Construction Division
Additions & Alteration Charges Approval Form

GULMOHAR RESIDENCY

Details of Additions & Alterations

Flat No	208	Block no.	' D '
Flat Area	1660 sft	Type	Deluxe / Luxury ✓
Buyer Name	S Purnachander Rao		
Phone No.	8555801525	Email	shakanurigurnachander@gmail.com

Description	Direction	Owners & Developers :	Date :	Promoted by
WORKING PLAN-1660 SR-B1 TYPE	N 	Modi Reality Mallapur LLP Project Name & Phase : Gulmohar Residency	25.09.2020 Prepared By : Jayaprada Approved By : Sobham Modi Scale : N.T.S	Modi Properties Pvt Ltd Phone : +91-48-66335531

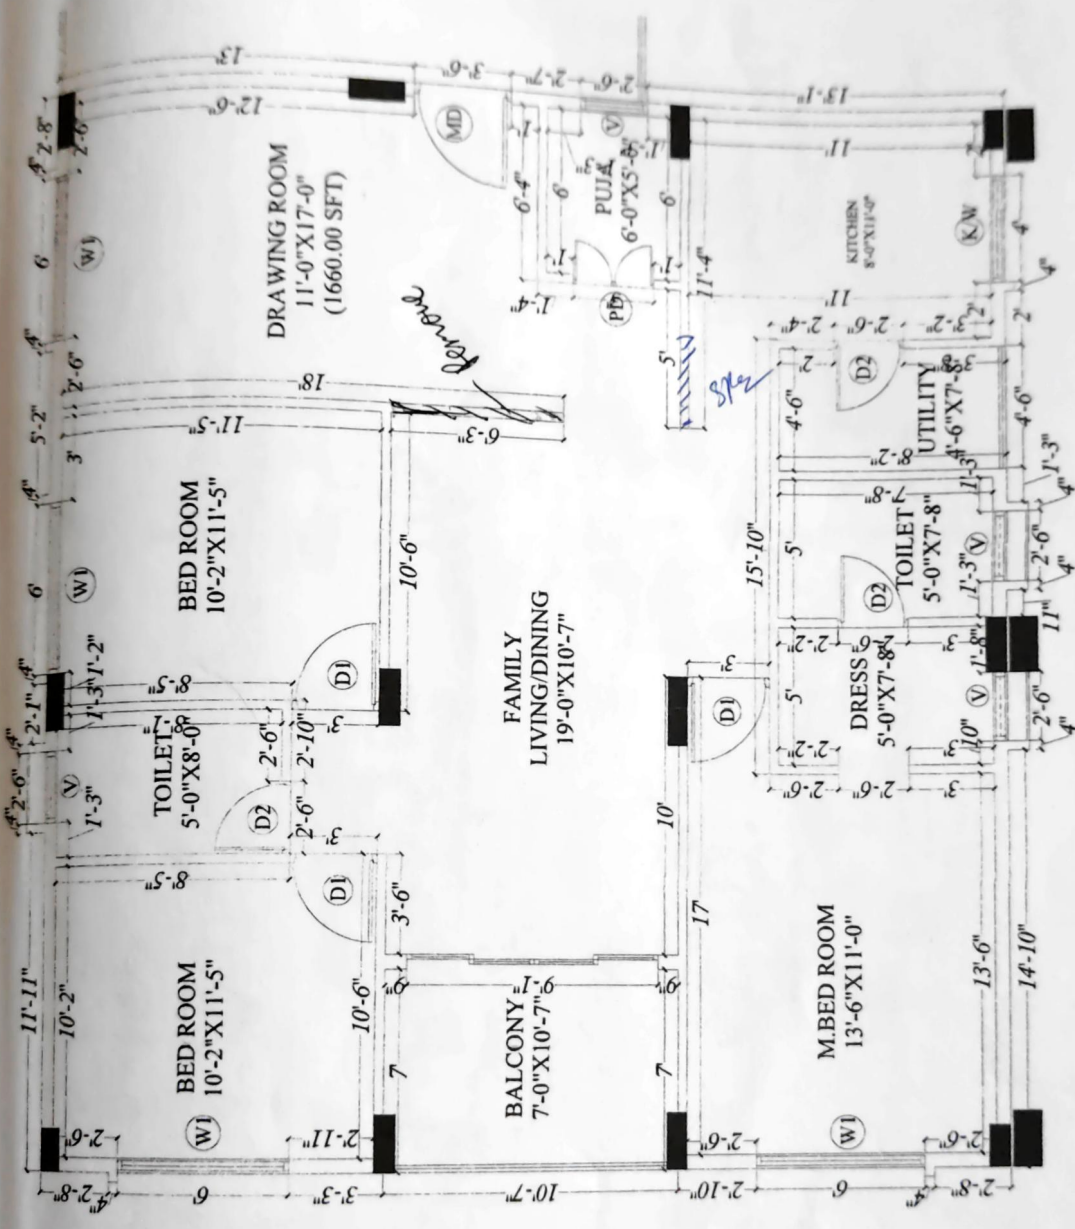
Changes in kitchen platform: (mark on plan)

① no need RCC platform not required
going with ~~our~~ own kitchen work

Other Changes:

1) ~~ceiling~~ RCC platform for SS sink.

ELECTRICAL PLAN -B1 TYPE-1660 sqft

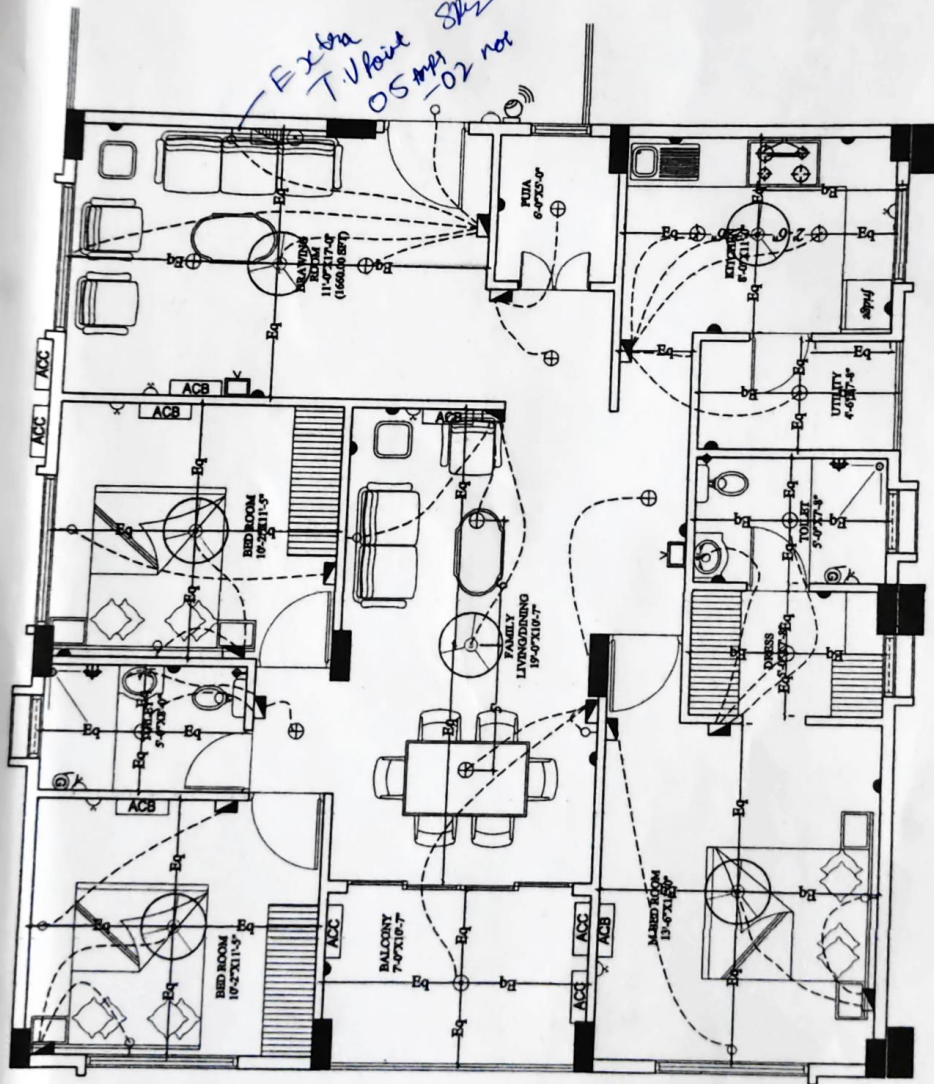
Changes in electrical points: (mark on plan)

1) Extra 0.5 Amps - 02 nos at Hall as per plan
